ORDINANCE NUMBER 2016-09

**AN ORDINANCE OF THE TOWN OF PARADISE VALLEY,
ARIZONA AMENDING THE PARADISE VALLEY ZONING
ORDINANCE, Article XXII, HILLSIDE DEVELOPMENT
REGULATIONS**

Section 1. Article XXII, Hillside Development Regulations, Section 2200- 2209 are hereby
amended (with deletions shown as ~~strikethroughs~~ and additions shown in **bold type**):

FIGURE 3 – PRIMARY RIDGE LINE DESIGNATION

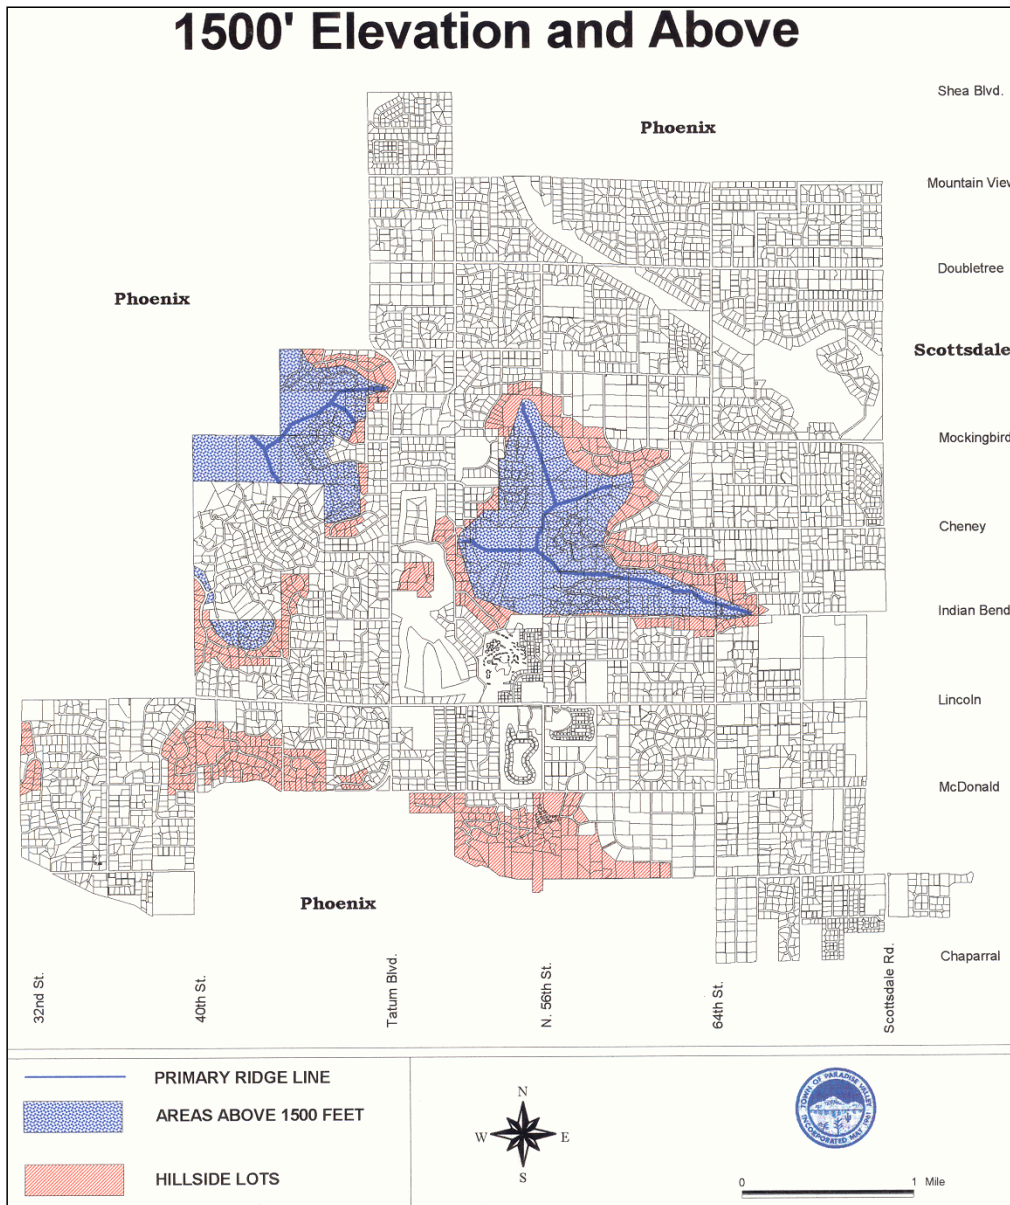
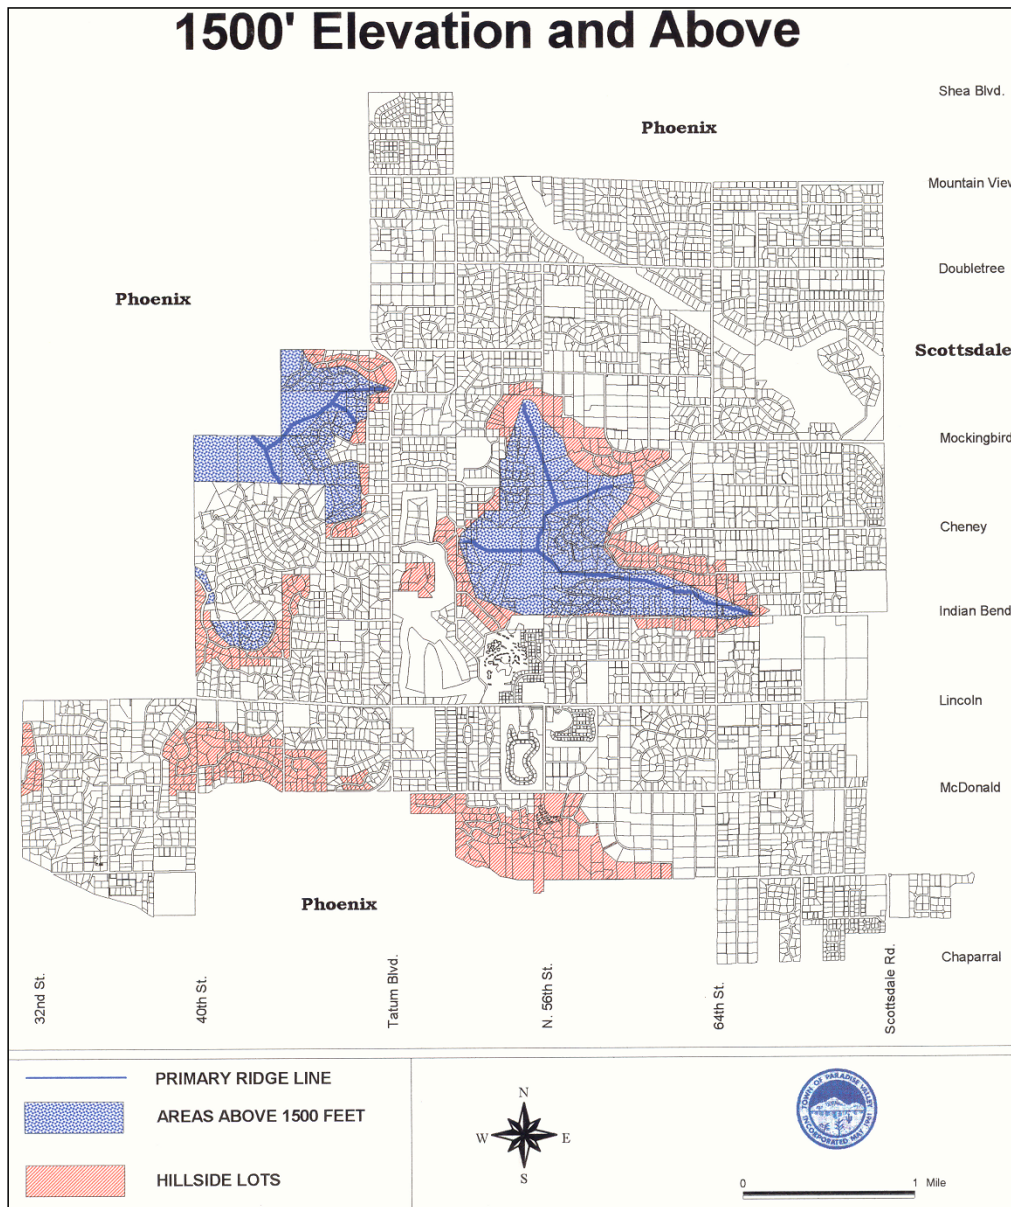
Commented [GB1]: Figure 3 Moved after Definition Section on Page 9

FIGURE 5 – BUILDING HEIGHT IN HILLSIDE

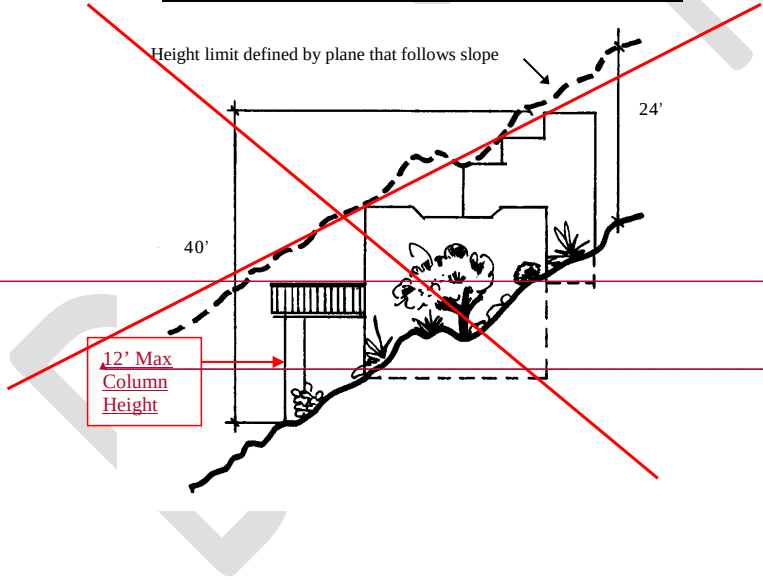
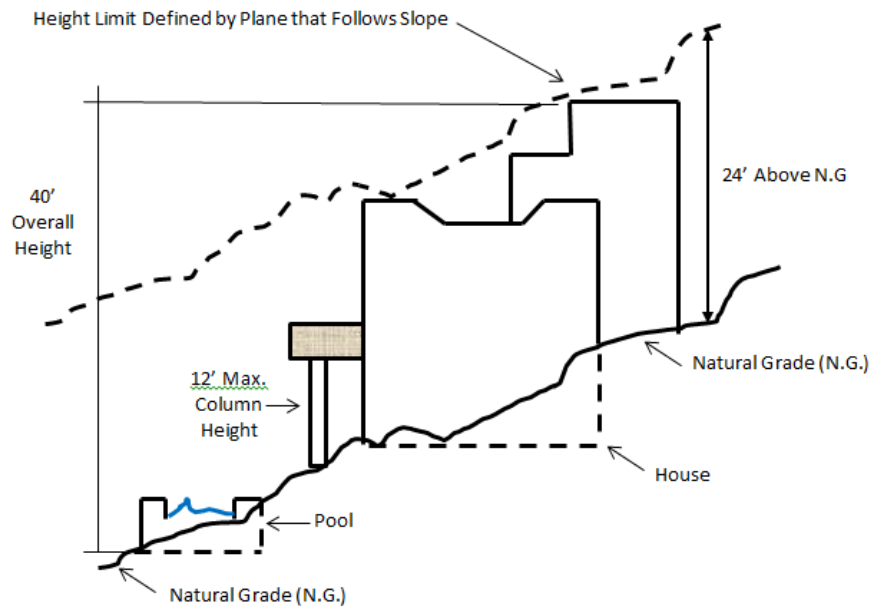
Commented [GB4]: Figure 5 to be updated to reflect these edits.

Commented [GB5]: Update Figure 5 to clarify measurement of 40' maximum height limit.

- iii.3. The maximum overall height of the building or structure, including chimneys and accessory buildings, shall not exceed forty (40) feet from the highest point of ~~the building to natural grade at the lowest point adjacent to the building structure or column of a building or structure to the lowest point of Natural Grade at the lowest building or structure (excluding driveway retaining walls) --(see FIGURE 5).~~

FIGURE 7 - HEIGHT FOR A CANTILEVERED ELEMENT

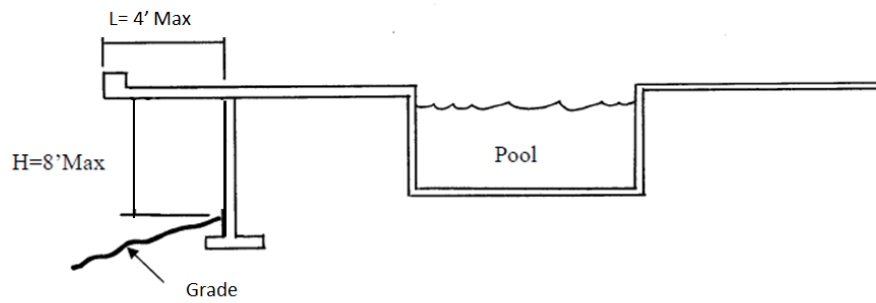
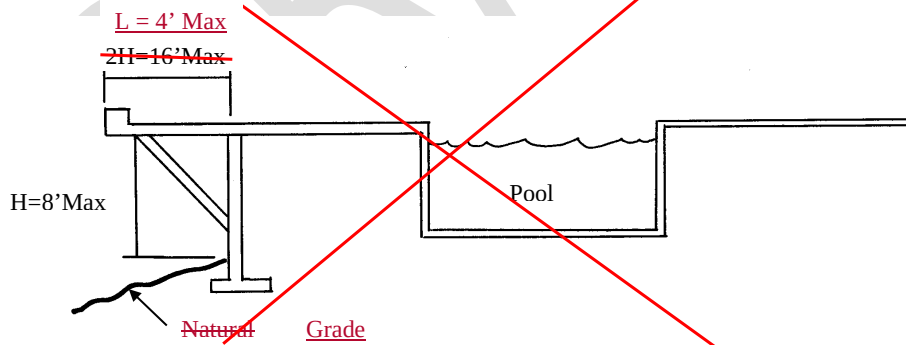
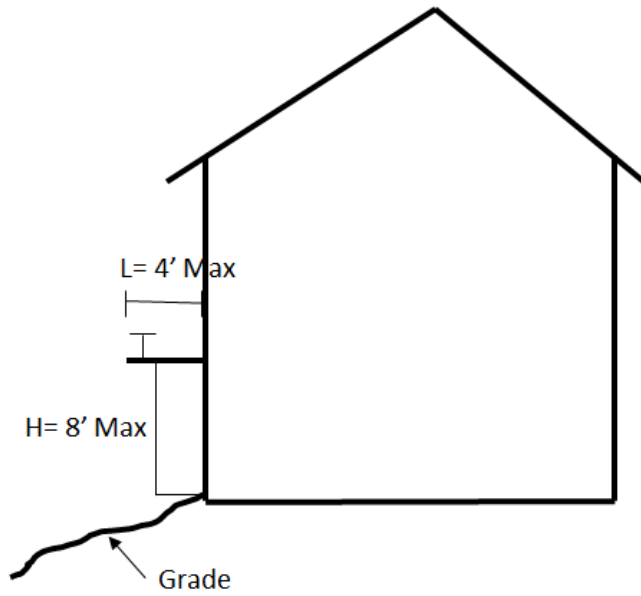
Commented [GB6]: New figures to be added to the code to illustrate these scenarios.

Commented [GB7]: Remove support from illustration and change horizontal to 4' max on Figure 7.

B. Structures employing the use of a cantilever may extend the cantilever a horizontal distance twice the height of the support. The maximum vertical height of the support shall be eight (8) feet. One half the area underneath the cantilevered element shall be calculated as disturbed area. (See FIGURE 7 below).

FIGURE 8 – TERRACED VERTICAL RETAINING WALLS

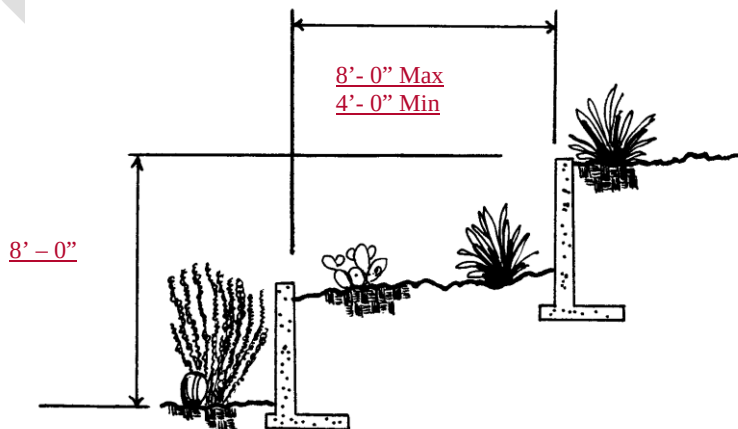
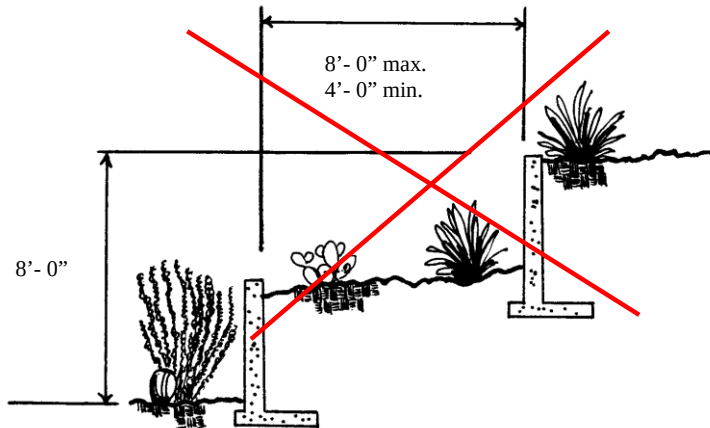
Commented [GB10]: Relocate Figure 8 below the text of 2207.VI.1.e.

e.e. A terraced combination of retaining walls shall be measured as a single retaining wall provided the combined walls are: 1) no more than eight (8) feet total vertical height; 2) terraced with a minimum distance between of four (4) feet and a maximum separation of eight (8) feet; and 3) contain appropriate vegetation between the walls so as to soften the visual impact of the combined walls (see **FIGURE 8**). These separation requirements apply to any single lot and do not apply to adjoining walls on neighboring properties.
